Project	IEEE 802.16 Broadband Wireless Access Working Group < http://ieee802.org/16 >
Title	Amendment to Security Primitives in Section 14.2.2.1, 14.2.2.2
Date Submitted	2007-03-08
Source(s)	Jung-Mo Moon, JeeHyeon Na, Mi-Young Yun, and Sangho Lee jhna@etri.re.kr ETRI 161 Gajeong-dong, Yuseong-gu Daejeon 305-700 Korea
Re:	Contribution on comments to IEEE 802.16g/D8
Abstract	Re-definition of EAP primitives in section 14.2.2.1
Purpose	Adoption
Notice	This document has been prepared to assist IEEE 802.16. It is offered as a basis for discussion and is not binding on the contributing individual(s) or organization(s). The material in this document is subject to change in form and content after further study. The contributor(s) reserve(s) the right to add, amend or withdraw material contained herein.
Release	The contributor grants a free, irrevocable license to the IEEE to incorporate text contained in this contribution, and any modifications thereof, in the creation of an IEEE Standards publication; to copyright in the IEEE's name any IEEE Standards publication even though it may include portions of this contribution; and at the IEEE's sole discretion to permit others to reproduce in who

Figure XXX – EAP based Authentication Procedure on MS side

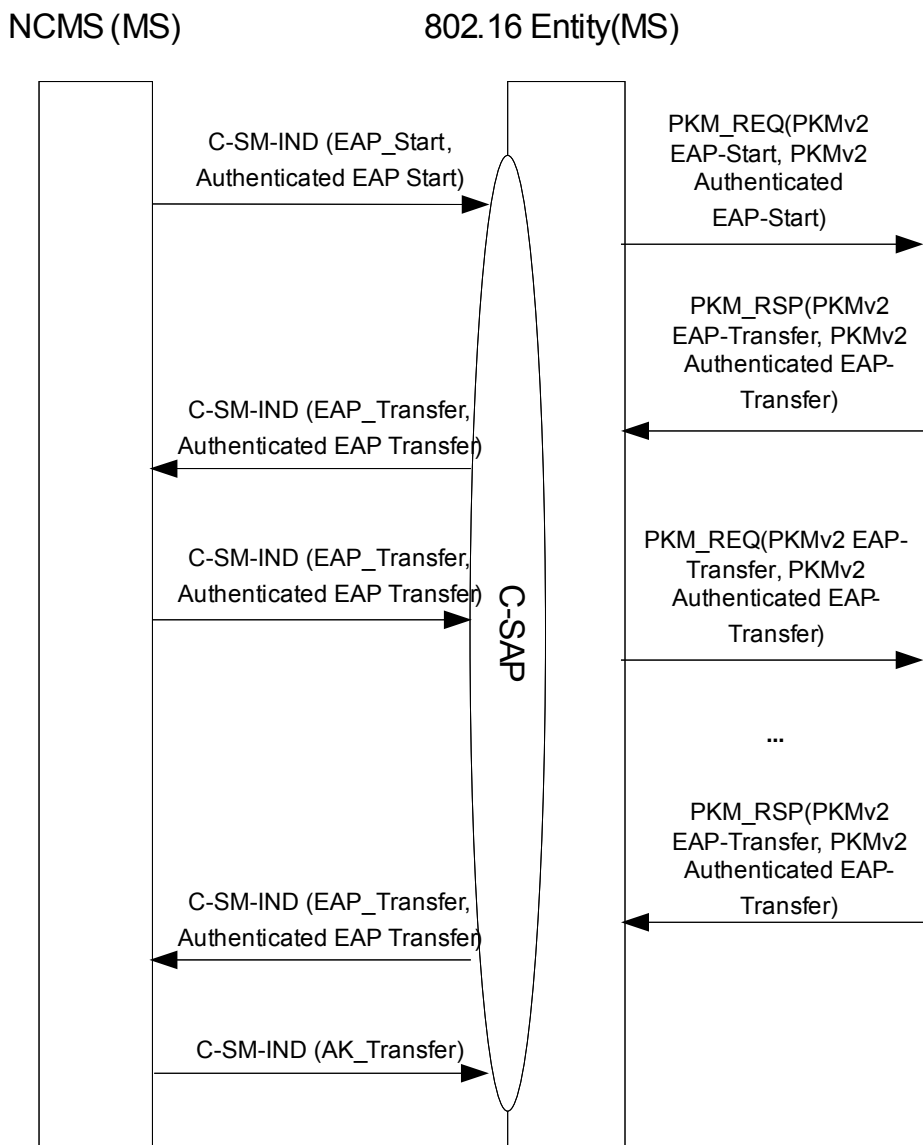
We propose to modify section 14.2.2.1 as follows.

1. add a figure to illustrate security primitives on MS side.
2. change each subsection to clarify and describes on each side (SS(MS) and BS side)

Figure XXX and 473 shows EAP-based authentication procedure between a BS-802.16 entity and a NCMS on MS and BS sides and an AAA Services entity in NCMS as follows:

[Insert the figure XXX to the following figure Section 14.2.2.1]
